Iowa County- Health and Human Services Building

Facilities Condition Review

Iowa County- Health and Human Services Facility

DRAFT Report January 16, 2023

Recommendations

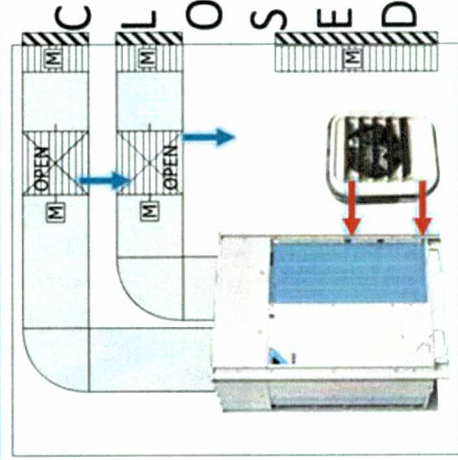
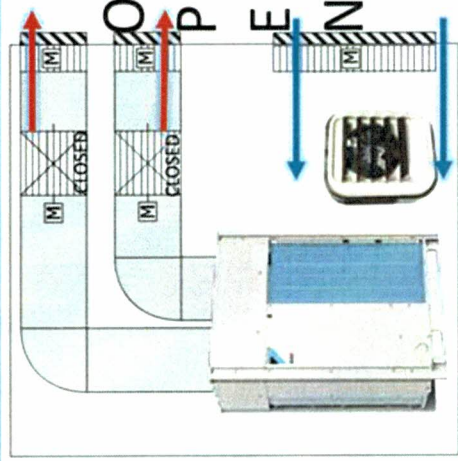
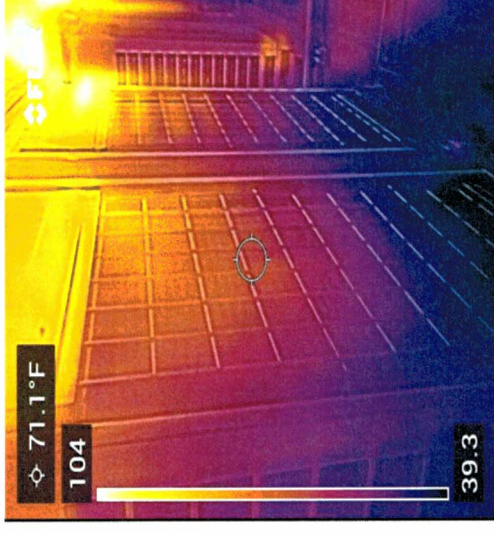
- Improve exhaust ductwork configuration
- Install motorized dampers to control outside air
- Discharge of unit heaters should not be directly onto VRV
 - *False load*
 - *Compressor failure*

Figure 5. Gas fired unit heater installed near top of penthouse with discharge air directed down toward VRV condensers. (On the day of our visit, the shown Unit Heater was not operational).

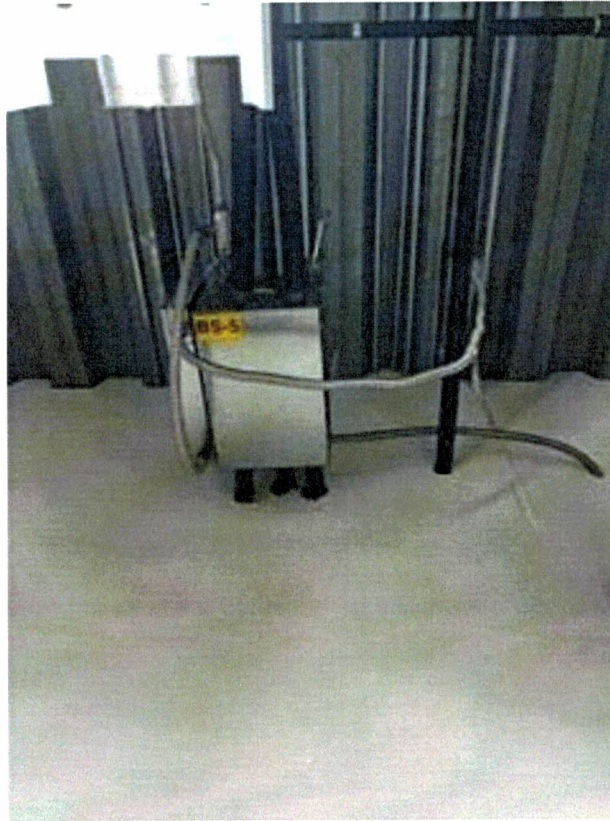
3. It is recommended to not have the unit heater discharge air directed down directly onto the VRV condensers. Potentially this configuration could “false load” the VRV condenser actual outdoor air sensor in the unit into staying in the cooling mode and locking out the heating mode. At 75 degrees F as sensed by this sensor heating mode is locked out and the unit stays in cooling mode.

Figure 10. Thermal image showing discharge from unit heater directed onto VRV condenser. Note that edge of VRV condenser is warm and is much cooler farther from unit heater discharge.

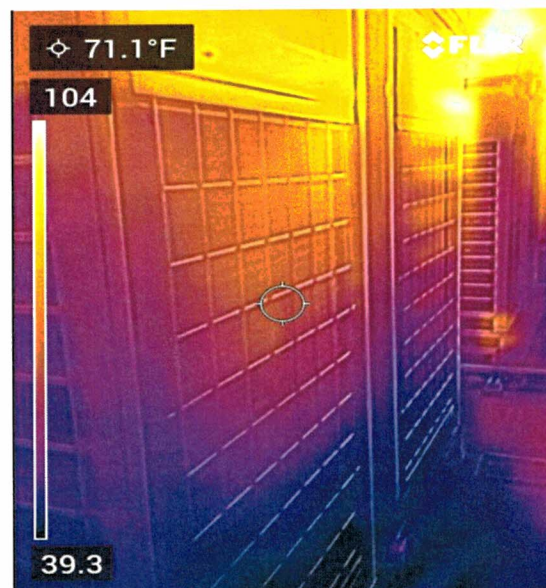
1. There is a non-uniform temperature profile across the penthouses. Warmer air is present at the top of the penthouse and much cooler air near the floor. Also colder temperatures are seen farther away from the heater.
2. The VRV condensers have non uniform air temperatures across their coils.
3. The combination of cold air and non-uniform temperature profiles on VRV condensers is impacting performance of the system in the heating mode.

Figure 15. Graphic on recommended damper placement. The left graphic is for summer operation and the graphic on the right is for winter operation.

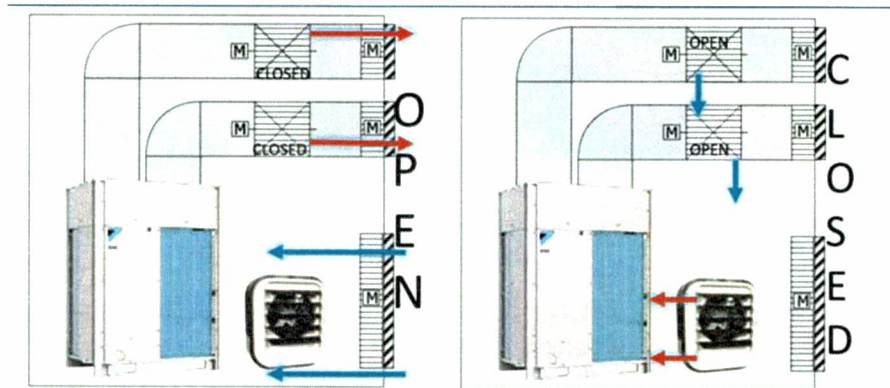
1. In order to allow the VRV condensers to operate correctly, the penthouse temperature needs to be uniform and stable above at least 40 degrees F minimum. To accomplish uniform and stable temperature it is recommended to add motorized dampers to the outside air intake louver and two dampers in the discharge from the VRV condensers. One damper in the discharge would recirculate air back to the penthouse and the other damper would exhaust air to the outside. Below are two graphics for damper placement:

Figure 17. Graphic from Daikin sales representative showing recommended exhaust duct arrangement

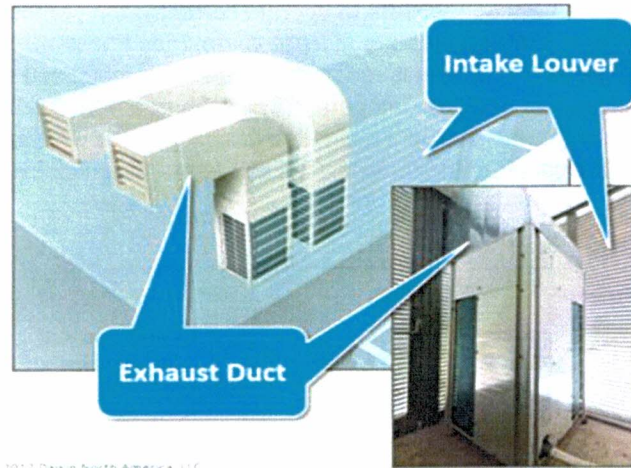
2. The existing gas fired unit heaters can be used to help maintain temperature in the penthouse after the new dampers are installed. Discharge from the unit heaters should be modified to prevent potential "false" readings of the outdoor sensor on the Daikin units. Adding some distribution ductwork would also be beneficial to distribute warm air more uniformly throughout the penthouses.
3. To prevent potential short cycling of discharge air from the VRV condensers, each condenser should be individually ducted to the building exterior per Daikin sales representative recommendation.
